MEMORANDUM

**Re: Shepherdstown Opera House Renovation
ADDENDUM No. 2**

The following information amends or supersedes the current issue of architectural, structural, and MEP drawings/specifications dated June 22, 2020.

P0.2

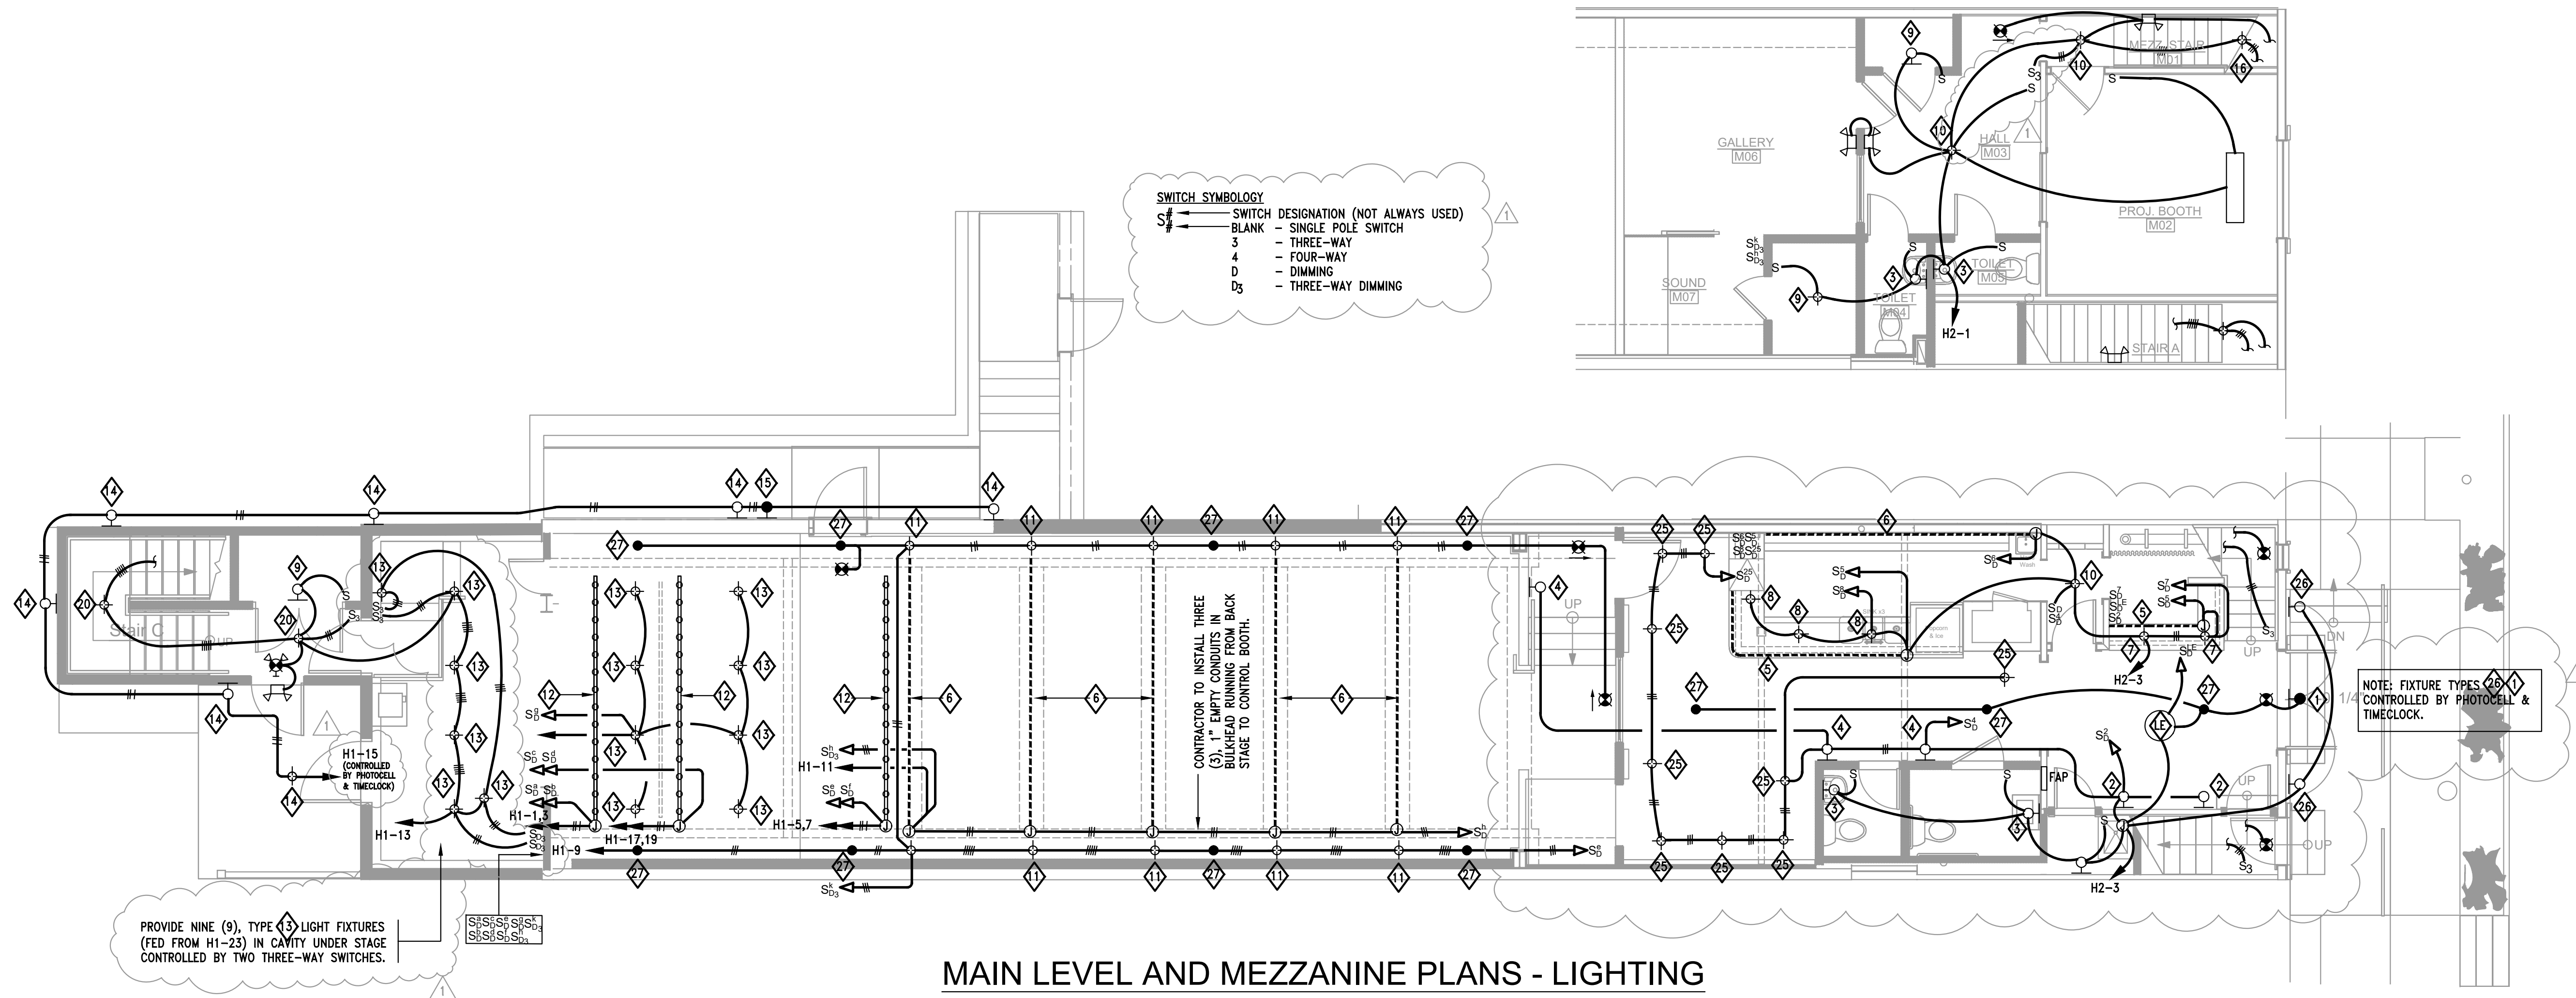
11. Sheet P0.1: **REVISED PLUMBING FIXTURE SCHEDULE (ATTACHED)**
12. Sheet P0.2: **REVISED PLUMBING SPECIFICATIONS (ATTACHED)**
13. Sheet P1.1: ADD FLOOR SINK IN 102A (SEE REVISED PLUMBING FIXTURE SCHEDULE) FOR INDIRECT DRAINAGE OF THREE-COMPARTMENT SINK

MAIN LEVEL & MEZZANINE PLANS

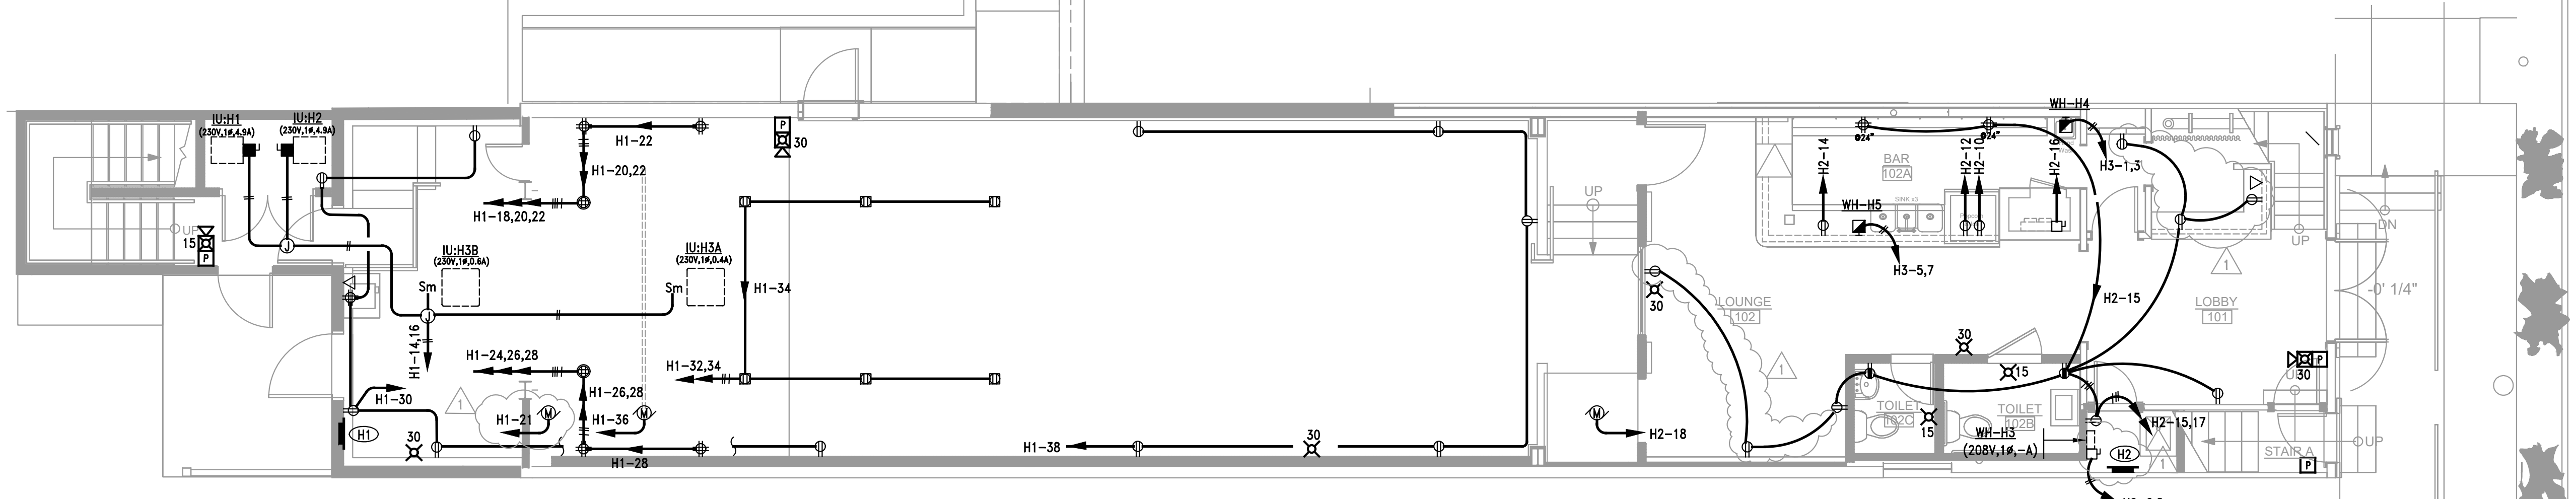
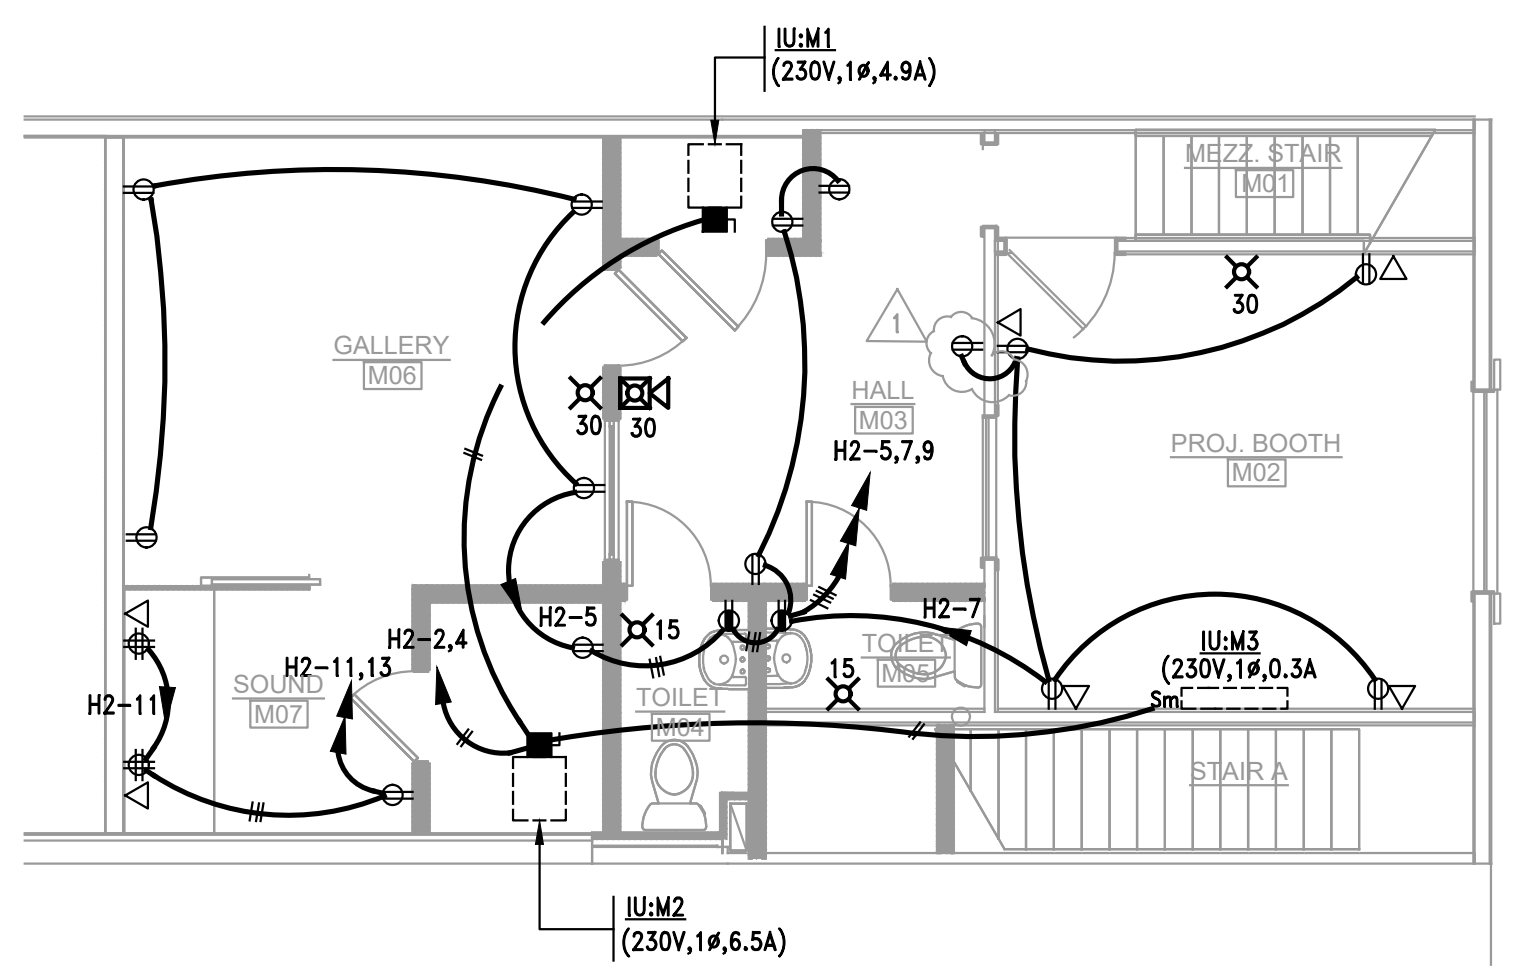
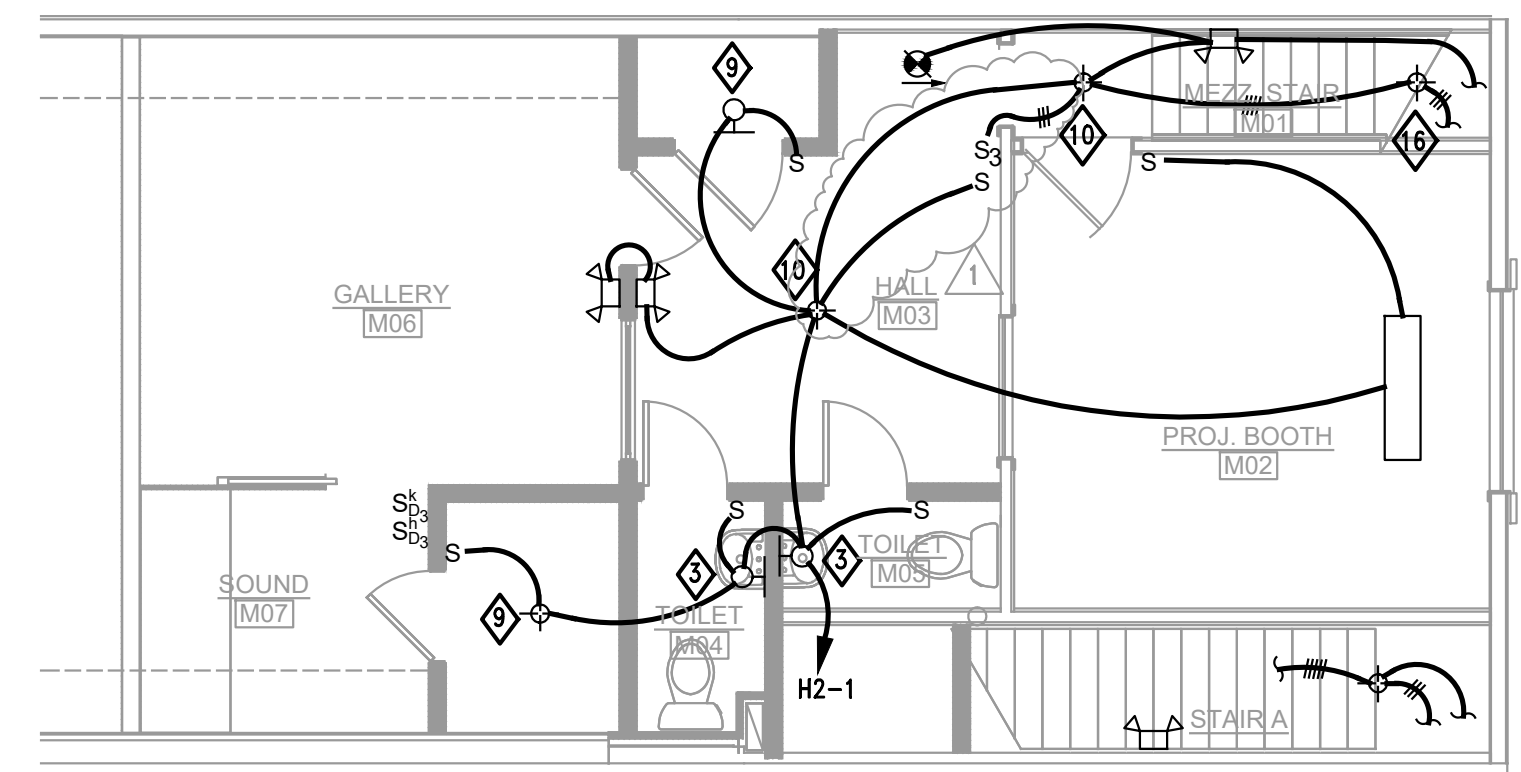
31. Is there a preferred washer machine box. **Guy Grey Model T or approved equal**
32. Electrical devices shall all be brown. All device plates shall be bronze plated steel. All light fixtures shall have dimmer switches except public bathrooms (use occupancy sensor switches for public bathrooms) and technical theater lighting. Provide Ariadni (Lutron) toggle switch with dimmer slide on side.
33. Add 3-way switch to entry corridor lights in both third floor apartments. Provide fixture 17 above shower in room 208A.
34. Partition between Lounge and Auditorium shall be a 2x4 wall. Delete reference called out as 2x6 wall on Structural drawing S.1. Lintel above window in this door shall be (2) 9 ¼" x 1 ¾" LVLs instead of (3) 7 ¼" x 1 ¾" LVLs.
35. Sheet E1.1: **See revised (clouded) changes to electrical and power plan (ATTACHED)**
